PRELIMINARY REPLAT

LOTS 15 & 16-B, BLOCK 2
 HILTON PARK, PLAT # 169,107 F.R.D.

RP023-16 (Hilton Park)

Specific Request: To abandon the common lot line between Lots 15 & the south ½ of Lot 16, Block 2, Hilton Park, to create a single lot of 16,200 square feet within the NW ¼ SE ¼ Section 8, T1S R1W.

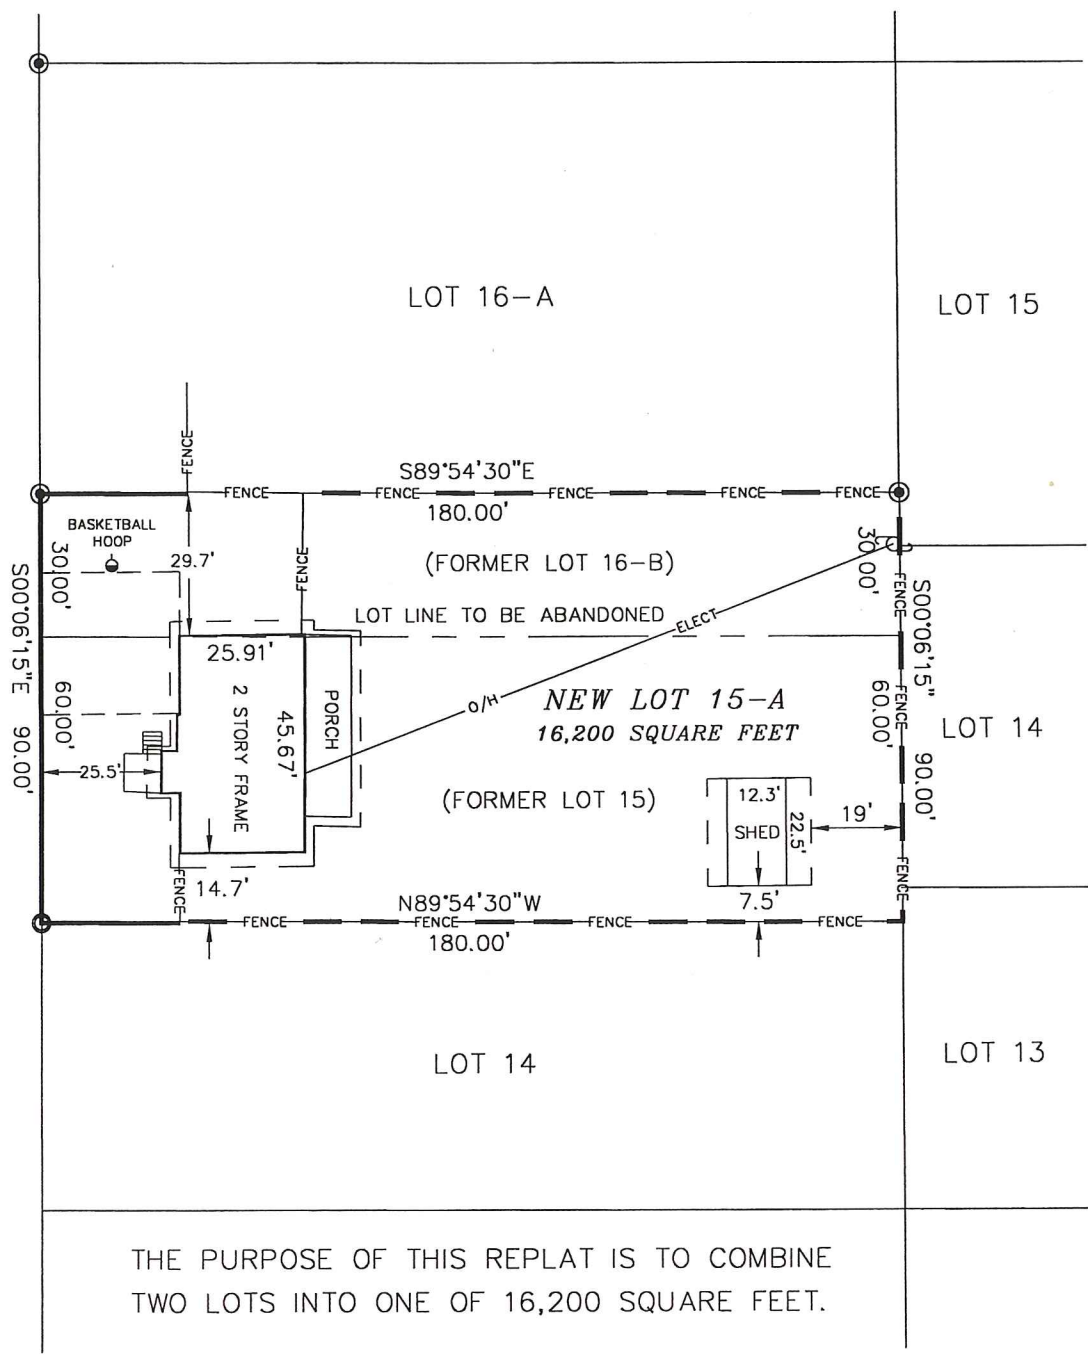
Assessing: Lot 16B as shown on the plat is legally known as the south portion of Lot 16 Block 2 Hilton Park as we have nothing to show us the description is Lot 16B.

Zoning: Proposed Lot 15-A meets TF requirements

Street Naming/Addressing: Street names are spelled correctly and property is correctly addressed.

GVEA: No objection, requests the addition of utility notes and to show the 10' wide utility easement on the back of the lot. Also requests review of the final plat.

1. GVEA and ACS shall review and comment on the final plat.
2. IGU shall be given the opportunity to review and comment on the final plat.
3. All easements of record shall be shown on the final plat.
4. Appropriate notes shall be placed on the final plat.
